CITY PLANNING COMMISSION

APPLICATION: Plan Review of a 20 unit apartment complex in the Multiple Family Review (R-2B-R zone).

LOCATION: Southwest corner of Gloria Drive and Rivergate Way

P87-319

SITE PLAN

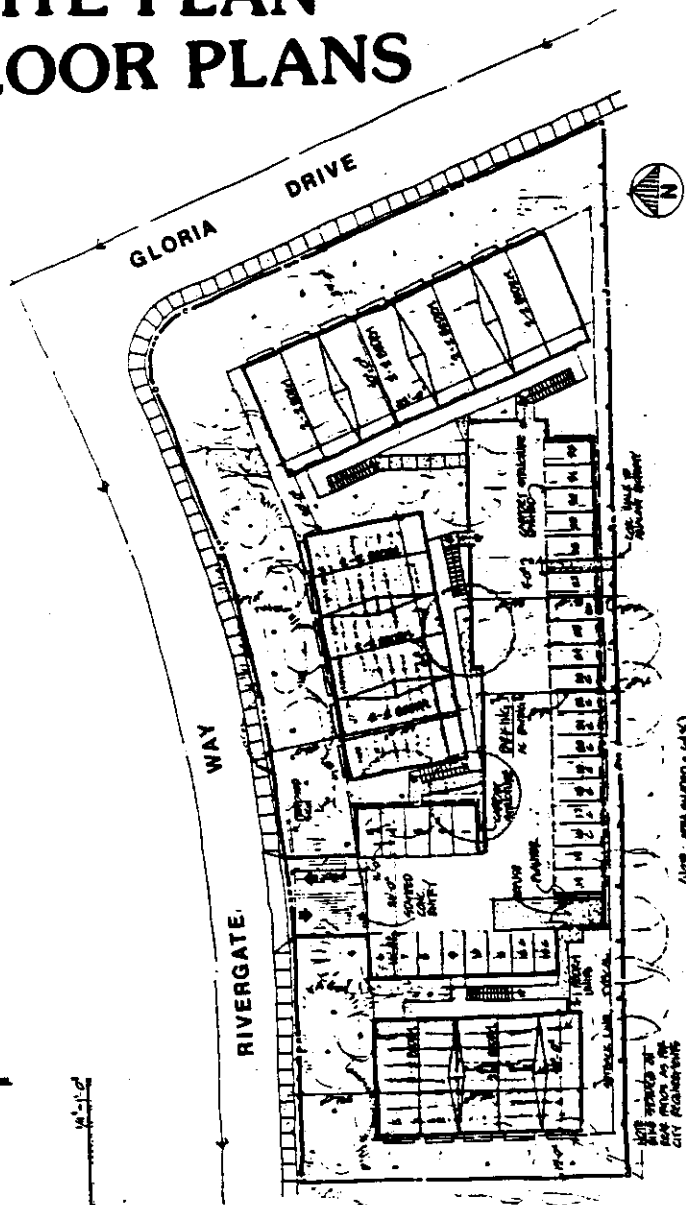
The project is designed with three separate two-story structures. One building fronts along the 25 ft. setback of Gloria Drive, another fronts along the 25 ft. setback of Rivergate Way and the third along the 15 ft. rear yard setback of Rivergate Way. Parking is mainly along the interior side setback away from street view. Twenty-four of the 32 parking stalls are covered, and all stalls will utilize a two foot parking overhang into landscaped planters. Carport elevations should be submitted for staff review and approval. Staff recommends the 25 foot setbacks along Gloria Drive and Rivergate Way be landscaped with four feet high undulating berms with grass and trees. The majority of trees should be 15 gallon evergreens, to compatible with the well designed street side landscaping of the Rivergate Apartment located on the northeast corner of Gloria Drive and Rivergate Way. The applicant has indicated they will use a minimum of 75 percent evergreen trees and shrubs along street setbacks and will likely consist of redwoods and sequoias.

Liquid amber trees will be used adjacent to the driveway to allow visual access to motorists. In order to buffer adjacent halfplex units, evergreen trees should also be planted in the rear yard setback. The trash enclosure has been designed to provide landscape planters around the periphery of the enclosure.

5. A revised landscape shading and irrigation plan shall be submitted for staff review and approval prior to issuance of building permits. The landscape plan shall include the following:

- a. Evergreen trees shall be placed in the rear yard setback to buffer the second level balconies from adjacent halfplexes.
 - b. A minimum of 75 percent of all landscaping in the 25 foot front and street side setbacks shall consist of evergreen trees and shrubs planted on a minimum of four foot high undulating grass berms. At least half of the trees in the 25 foot front and street side setback shall be 15 gallon pines to blend in well with street side landscaping of other apartments in the surrounding area. The remaining landscaping shall be compatible with the Phase I development to the south.

ELEVATIONS

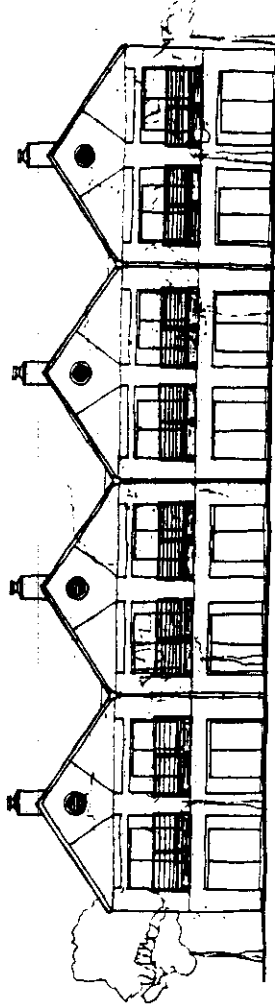
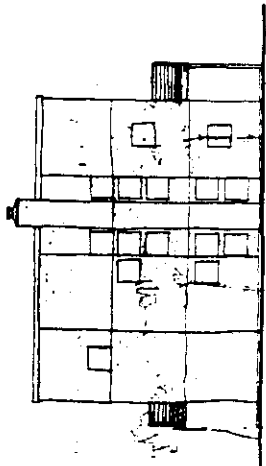
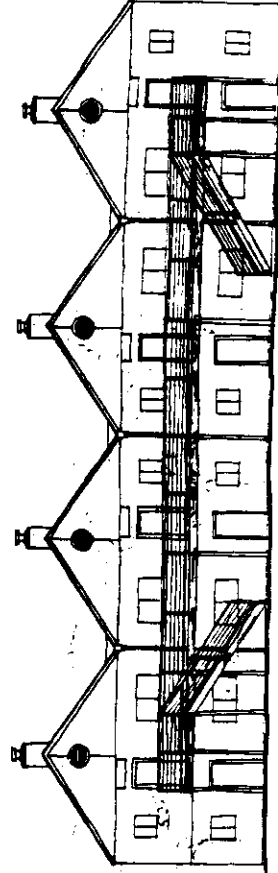
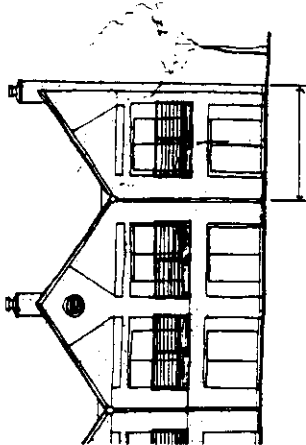
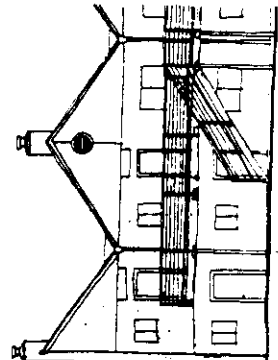
Overall, staff finds the proposed units attractively designed and compatible with the surrounding neighborhood. A condition of approval for Phase I indicated that the first and second floor patios be screened for security and aesthetic purposes. The applicant has submitted a detailed drawing of the porch enclosure (see Exhibit C). Solid walls with stucco siding are only provided for upper level porches. The applicant has indicated that grape stake fencing (six foot high) would be used on ground floor porch areas to allow for light and air circulation.

2. Revised elevations indicating screened patio areas shall be submitted for Planning Staff review and approval prior to issuance of building permits.
3. Bike storage proposed on rear patios must be provided for each unit. The type of facility must meet City requirements.
